# UNITED STATES PATENT AND TRADEMARK OFFICE

10/686,480

<b>Office Action Summary</b>	<b>Application No.</b> 10/686,480	<b>Applicant(s)</b> NISHIMURA ET AL.	
	<b>Examiner</b> Tony Chuo	<b>Art Unit</b> 1795

## **DETAILED ACTION**

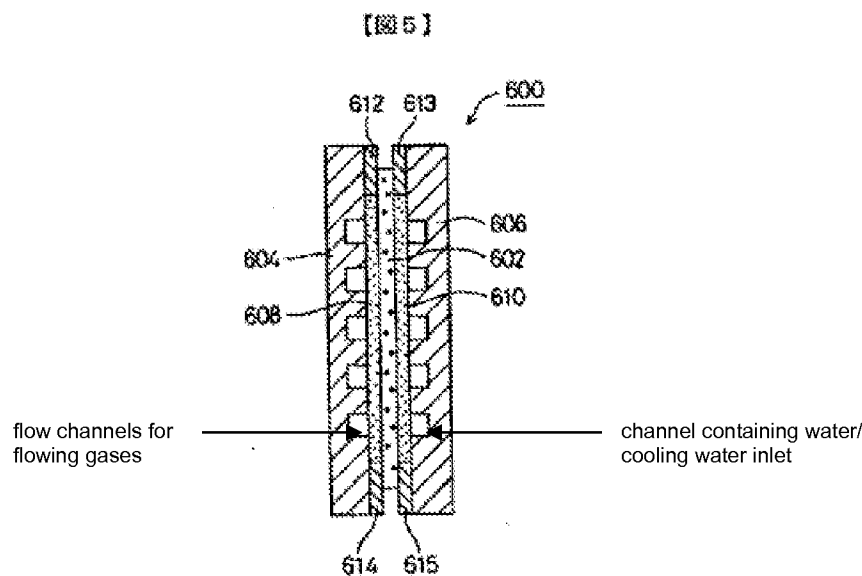
Regarding claims 33 and 46, the Kawazu reference discloses a fuel cell assembly comprising: a humidifier “200” and a plurality of fuel cell units “10”, wherein each of the fuel cell units comprises an electrolyte membrane “11”, a cathode “12” adjacent to one face of the membrane, an anode “13” adjacent to the other face of the membrane, a gas diffusion layer adjacent to the cathode, a gas diffusion layer adjacent to the anode, a separator “14” having a flow channel for flowing oxidizing gas, which is adjacent to the cathode, and a separator “15” having a flow channel for flowing fuel gas, which is adjacent to the anode, wherein the humidifier comprises a porous membrane “602” (porous water-retaining layer) for retaining water supplied thereto, wherein the porous membrane “602” communicates with a channel containing water (not labeled) by way of a porous carbon (filter) “610” for passing water, but not gas, the channel containing water exclusively supplying water to the porous membrane, supplying water thereto via the filter, wherein the porous carbon (filter) is disposed at a position where the cooling water inlet and the porous membrane communicate with each other, and wherein the humidifier adjoins an end of the plurality of the fuel cell units in such as relation that the porous membrane faces the flow channels thereby to transfer water introduced into the porous membrane to the fuel gas and oxidizing gas flowing in the flow channels, the flow channels for flowing gases being partitioned with a wall “612”,

“608”, “614” from the channel containing water (See paragraphs [0031],[0033],[0034],[0036],[0040], and Drawings 1, 3, and 5). It also discloses a porous membrane that is a hydrophilic polyolefin material (See paragraph [0037]). It also discloses a porous membrane “602” that takes water thereinto at a peripheral portion thereof, where the porous membrane is in contact with cooling water (See Drawing 5).

In response, the examiner disagrees because the Kawazu '704 does disclose a porous membrane "602" (porous water-retaining layer) that is in communication with a channel containing water by way of a porous carbon (filter) for passing water, but not gas, this water channel exclusively supplying water to the porous membrane, supplying water thereto via the porous carbon (filter) (See Drawing 5 above).
